REVISION OF TECHNICAL SPECIFICATION 3/4.8.1. - ONE-TIME FOOTNOTE TO DIESEL FUEL OIL STORAGE AND TRANSFER SYSTEM ALLOWED OUTAGE TIME

A. DESCRIPTION OF AMENDMENT REQUEST

Figure 1 Diesel Fuel Oil Storage and Transfer System

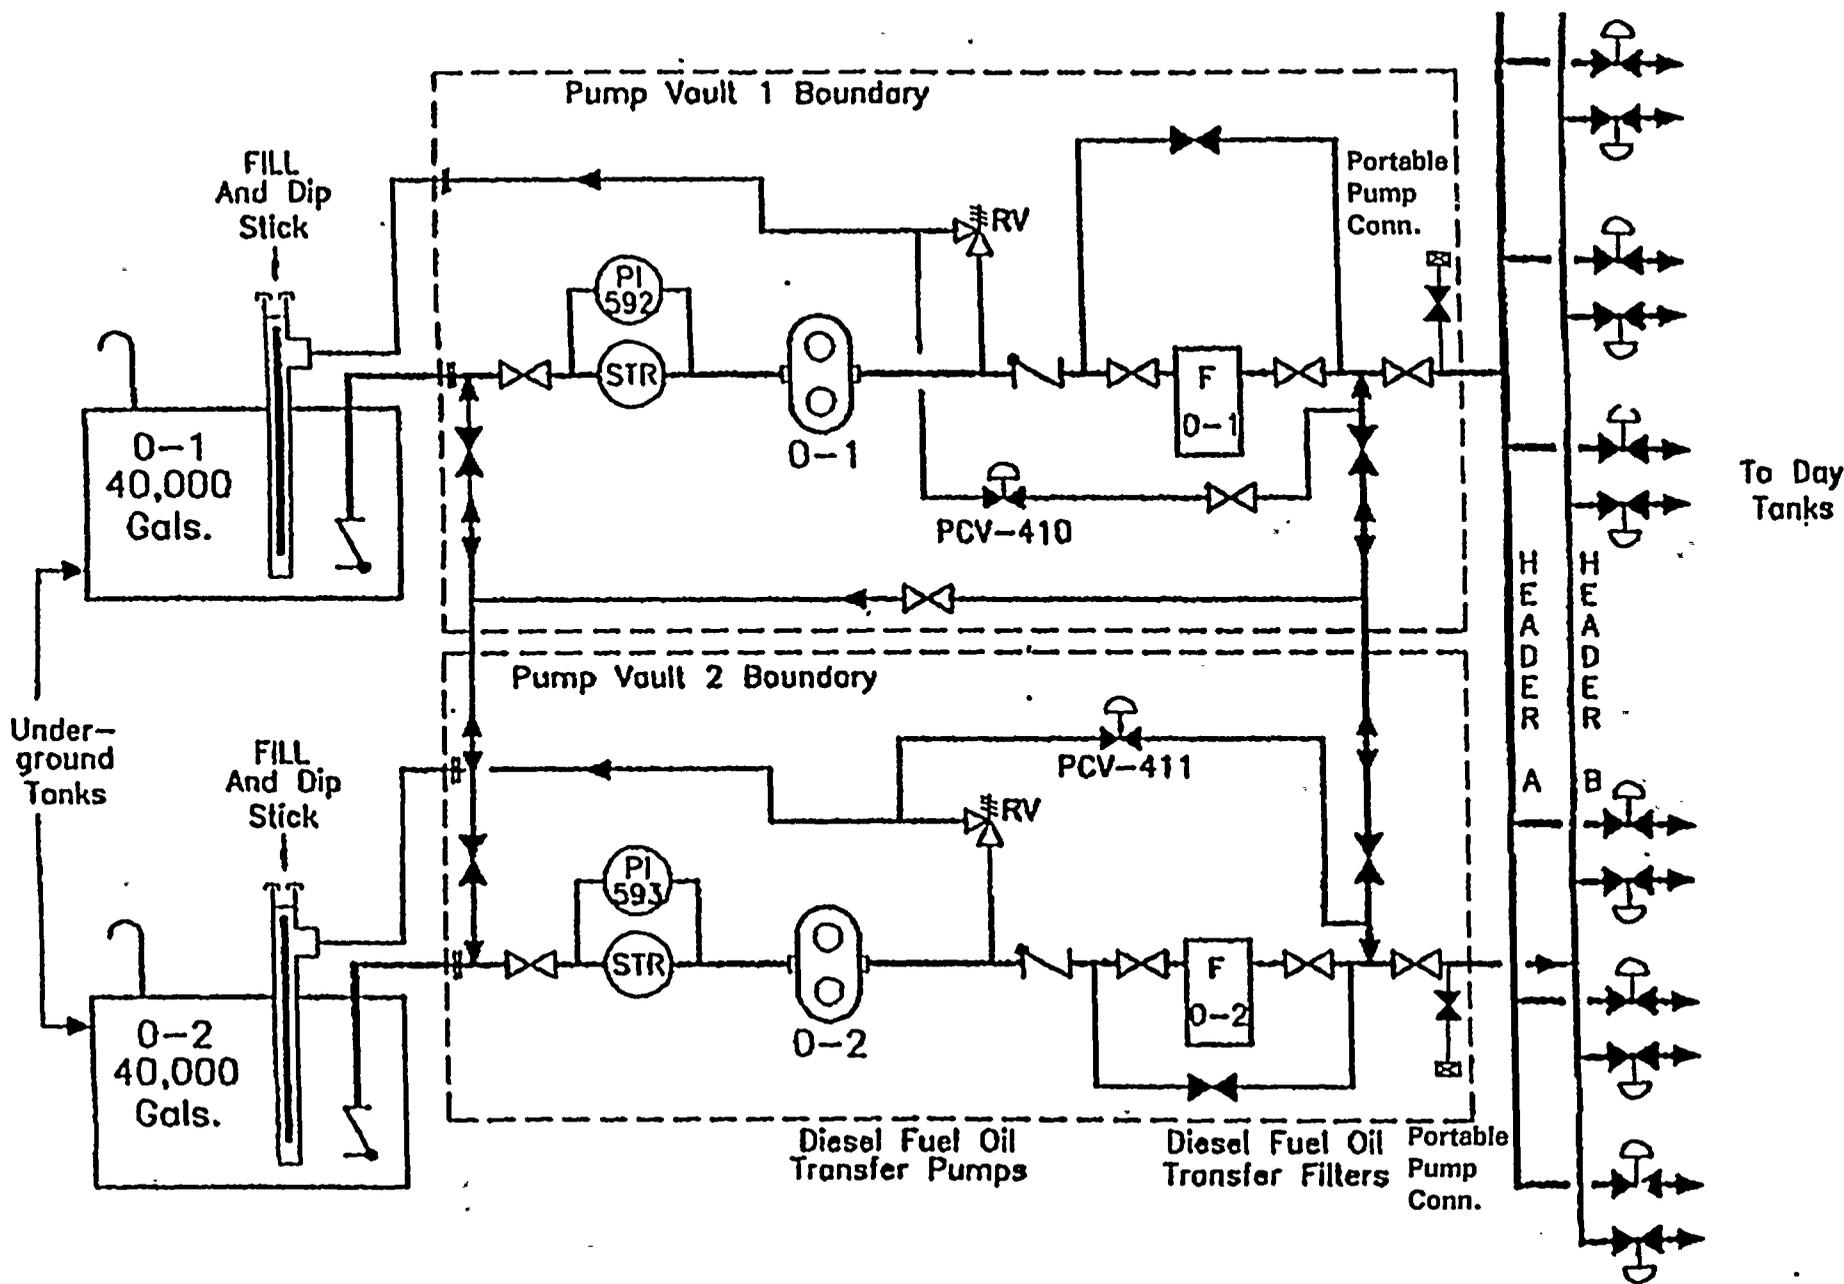
The DFO storage and transfer system consists of two 40,000 gallon storage tanks (0-1 and 0-2), two DFO transfer pumps (one pump per train), and the associated piping and valves required to connect the transfer pumps to the storage tanks and the individual day tank of each EDG. The system is designed to supply DFO from the storage tanks to the EDGs for Units 1 and 2.

Figure 1 shows a simplified single-line diagram of the DCPD DFO storage and transfer system. Further information on the DFO storage and transfer system design can be found in Section 9.5.4 of the DCPD Final Safety Analysis Report (FSAR) Update.

TS 3.8.1.1b.2. requires that a combined volume of at least 65,000 gallons of DFO be maintained for two units operating in Modes 1 - 4. Either DFO transfer pump is capable of supplying DFO from either storage tank to all six EDG day tanks via a DFO transfer pump suction cross-tie line. One transfer pump is capable of supplying all six EDGs operating at rated load.

The DFO storage tanks and the piping between the tanks and the DFO transfer pumps are buried and, therefore, require modifications to comply with the CCRs. Each DFO transfer pump is located in a concrete vault and is connected to the buried piping via a flanged connection upstream of the pump suction cross-tie line. The CCRs do require modifications to the DFO transfer pump vaults. However, these modifications will not require the DFO transfer pumps to be taken out of service. No modification to the DFO transfer pumps and suction cross-tie piping is required during the tank and piping replacement.

Modifications to each DFO storage tank and the piping between the tank and transfer pump vault will be performed on only one tank and its associated piping at a time. This will assure that one storage tank is operable at all times during the performance of the modifications. If the remaining operable storage tank becomes inoperable, TS 3.8.1.1, Action h., will be followed.

Both DFO transfer pumps will be operable during the performance of these modifications. The suction of the transfer pump associated with the inoperable DFO storage tank will be isolated from the tank being modified upstream of the pump suction cross-tie line. The suction cross-tie line valves will be opened. The associated DFO transfer pump will have the recirculation system valved out and the relief valve discharge routed to the other tank. This will allow either transfer pump to supply the DFO transfer system from the operable storage tank. If either DFO transfer pump becomes inoperable, TS 3.8.1.1, Action g., allowing 72 hours to restore the inoperable pump to operable status will be followed.

Figure 2 Location of Existing DFO Tanks and Temporary DFO Storage

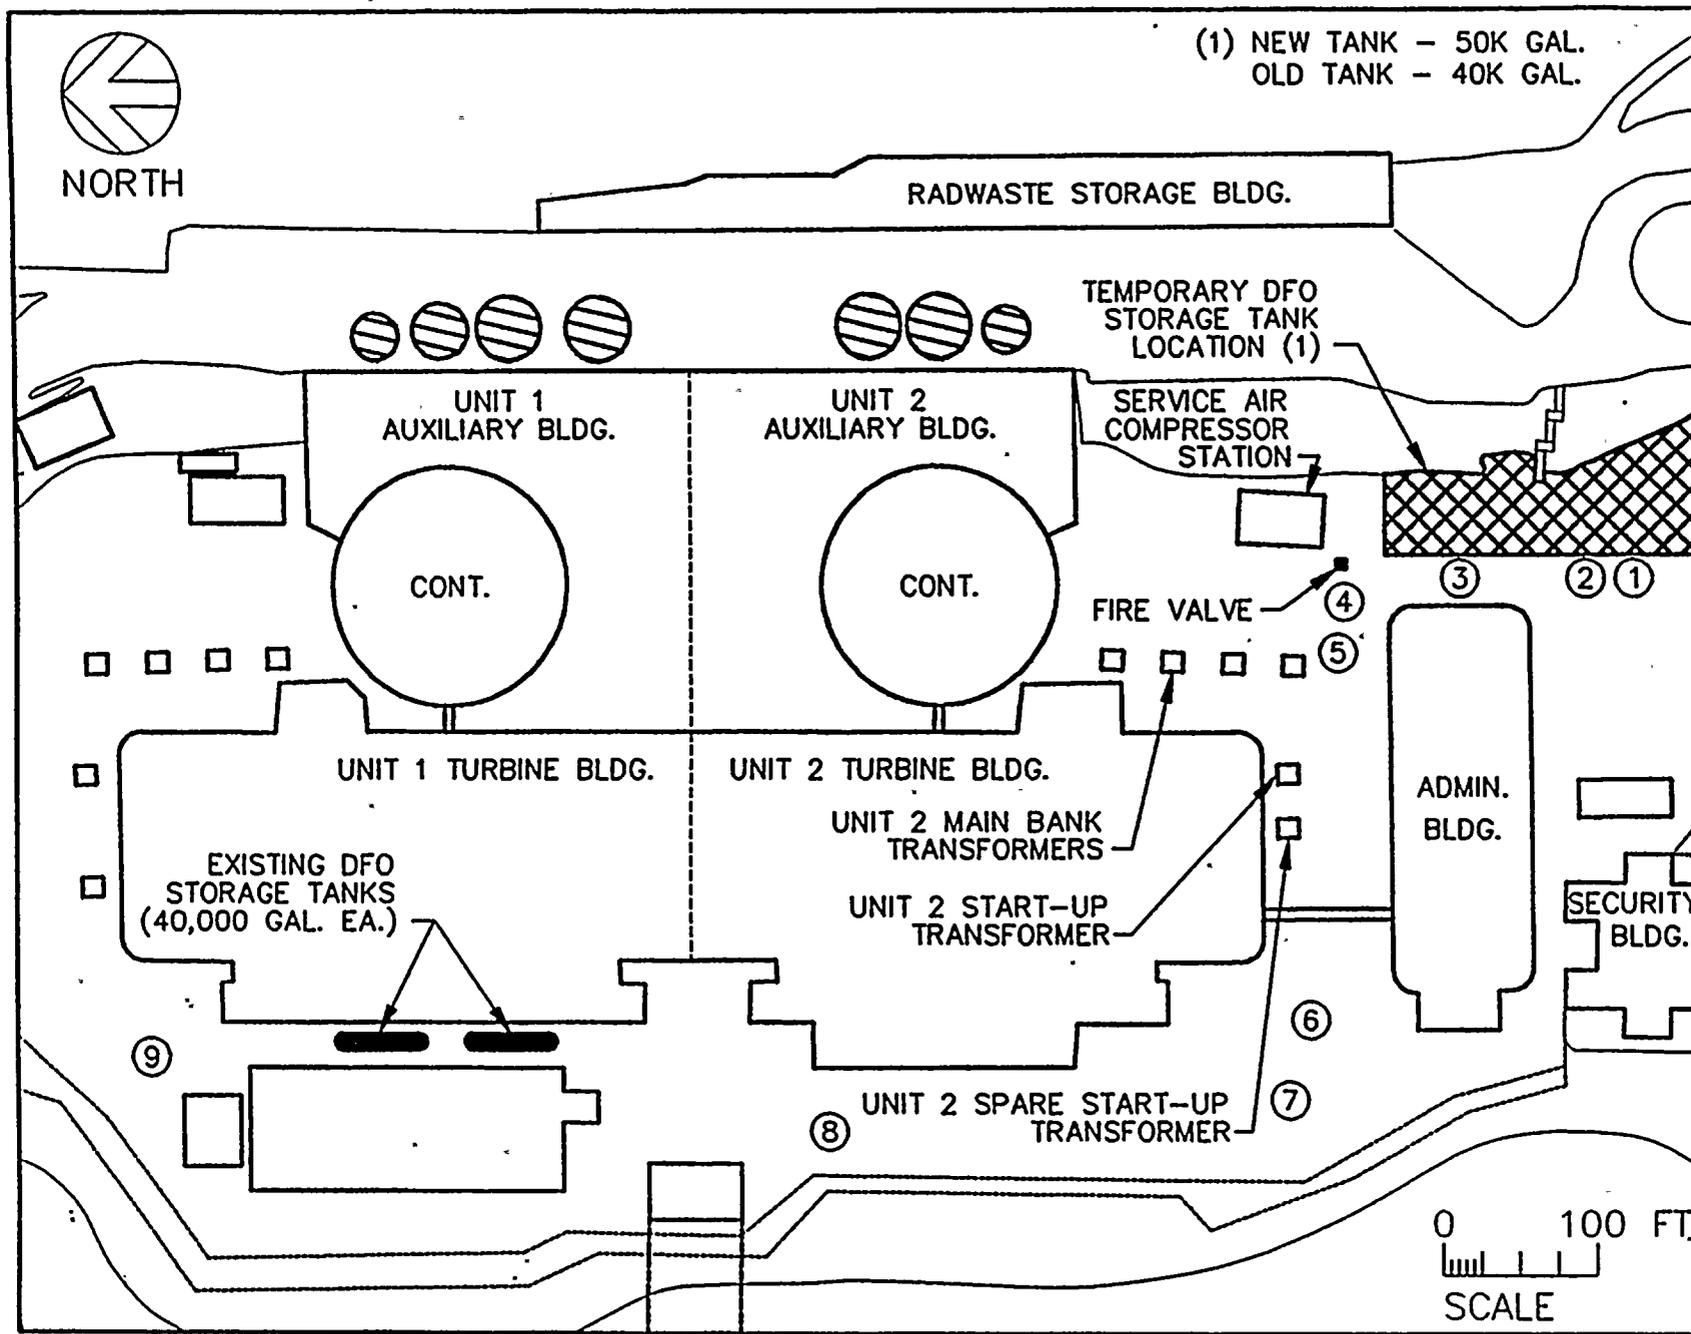
Each replacement DFO storage tank has an increased nominal capacity over the existing storage tanks of 10,000 gallons (approximately 25%). This size tank was chosen because it provides the greatest capacity, while allowing use of the existing tank location (i.e., in close proximity to DFO transfer pumps). The replacement tanks will be able to use the same concrete foundation as the existing tanks, are only slightly dimensionally larger, and therefore, are able to use the same location.

Underground storage in this location is restricted due to the proximity of the following: the circulating water tunnels which are less than 3 ft. below the DFO storage tank foundation; the Turbine Building west buttress structure; the Technical Maintenance Building; and the heavy load transport areas.

Figure 2 shows a simplified drawing of the DCPD plant protected area, identifying the location of the existing tanks and the area considered for the temporary DFO storage.

- a. The tank providing the temporary storage will be seismically supported to assure the tank maintains its function following a seismic event. The temporary storage complies with the requirements of FSAR Appendix 9.5B, Section F. FSAR Appendix 9.5B requires that all above-ground DFO storage tanks be located at least 50 feet from any building containing safety-related equipment.
